FREDERICK COUNTY PLANNING COMMISSION

TITLE: Danac Remainder: Amendment to Building "B"

FILE NUMBER: SP 94-10 (AP# 10974, APFO # 10975 & FRO #10976)

REQUEST: Site Plan

Exhibit #1 Overall Site Plan: Danac Remainder

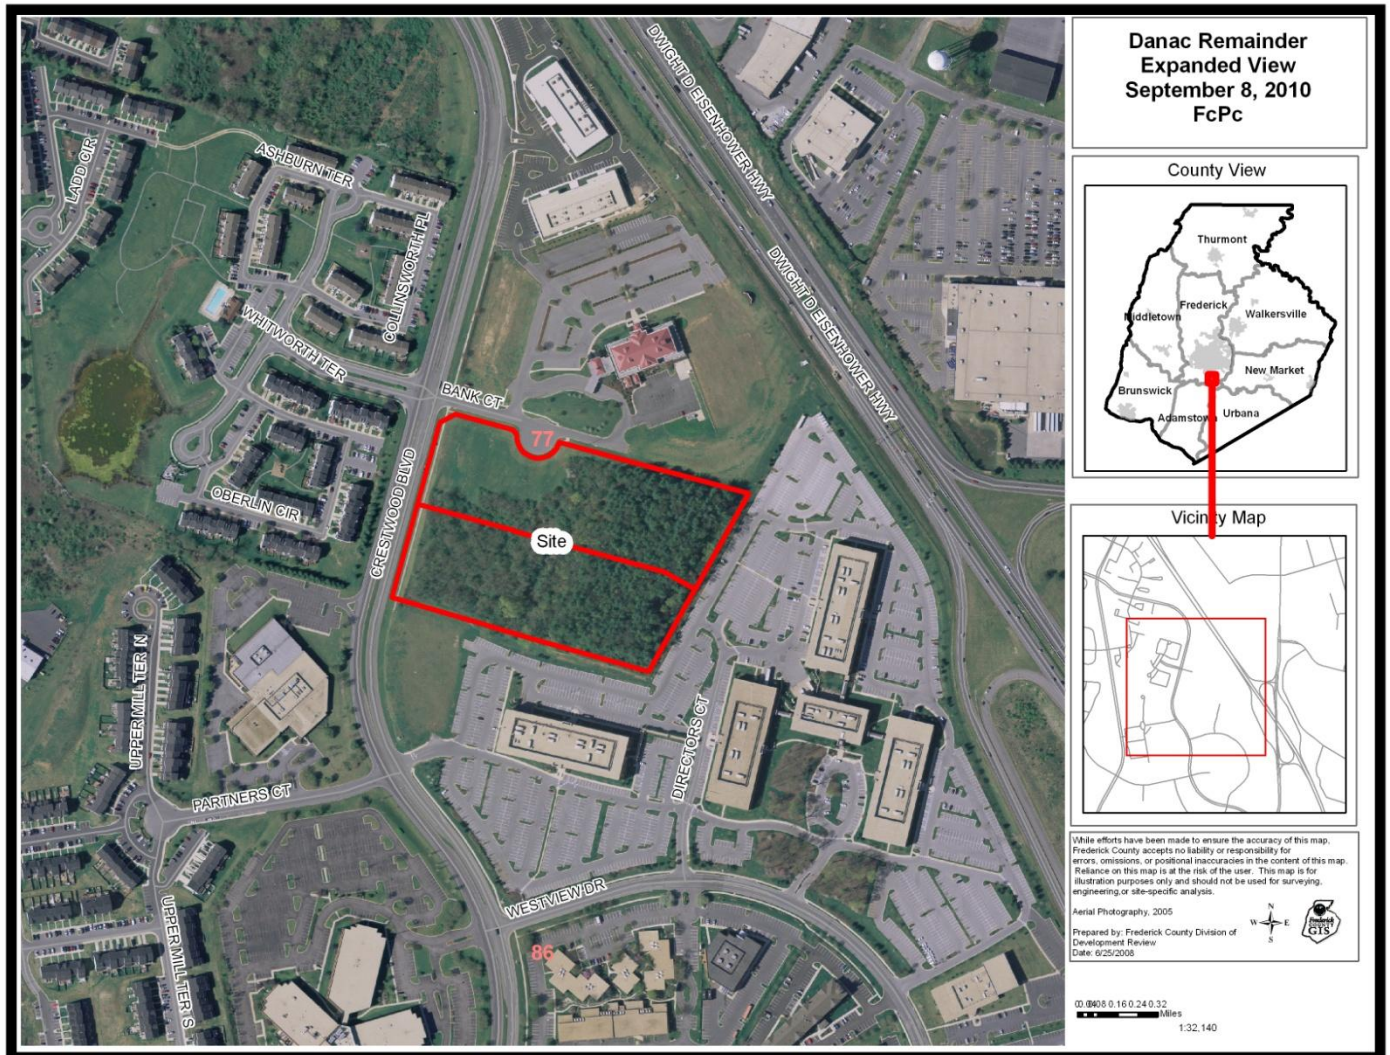
“Building A” is constructed and only proposing a shift in allotted square footage to reflect 60,000 square feet of Medical Clinic use. For 60,000 square feet of floor area; 1 space is required for every 200 square feet of floor area devoted to examination, treating room, office and waiting room. Therefore, 300 spaces are required for the medical clinic area. The remaining 5,000 square feet of floor area will be dedicated to professional offices including doctors’ offices, which do not meet the definition of medical clinic. For 5,000 square feet of professional office space floor area; 1 space is required for every 300 square feet, which equals 17 spaces.

“Building B” is not constructed and proposes 36,000 square feet of medical clinic use, with 4,000 square feet for professional doctor’s offices. For 36,000 square feet of medical clinic floor area; 1 space is required for every 200 square feet of floor area, which equals 180 spaces. The professional office area is proposed to be 4,000 square feet, requiring 14 spaces at 1 space per 300 sq ft of floor area.

Total parking spaces required for both Building “A” & “B” is 511; the applicant is proposing 175 spaces for Building “A” and 351 spaces for Building “B”, a total of 526 including 10 universal design handicap accessible 24’x20’ spaces, as well as 4 standard handicap accessible 21’x18’ spaces.

The Applicant is proposing 15 parking spaces over the maximum established by the Zoning code. Therefore the Applicant is requesting a modification to permit 15 additional parking spaces. (See Exhibit #4)

The Applicant is proposing no more than four (4) small 9' x 20' loading spaces and is seeking a modification of the full requirements of Section 1-19-6.21. The Applicant has provided the following justification for providing only four small loading spaces; (See attached Exhibit #5)

Lighting: The Applicant is proposing 16-foot tall freestanding light poles (measured from the ground to the light fixture). The Applicant has noted on the plan that lighting will not exceed 0.5ft/candles at the periphery of the site and lighting will be directional onto the site through the use of shielding and lighting orientation. The Applicant has provided a justification statement to exceed the 14-foot maximum light pole height required by Section 1-19-6.500.B.(1) of the Zoning Code. This modification request is only for the lighting surrounding Building "B", Building "A" received a lighting height modification during the initial site plan approval in December of 2006. The justification statement is attached as Exhibit #6. The Applicant has submitted and Staff has reviewed the photometric chart for the site and lighting.

Signage: The Applicant constructed a freestanding monumented sign for both parcels and a channel letters type building mounted sign for each building as shown on the plan. The signage calculation on sheet 2 of 7 indicates the maximum allowed signage is 177 square feet for each lot. The Applicant has provided a detail, which indicates the freestanding monument signs will not exceed 5.0 feet in height.

Staff has no objection to granting this modification for the parking surplus.

Staff has no objection to granting this loading space modification.

Staff has no objection to granting the requested modification.

Staff has no objection to conditional approval of the site plan.
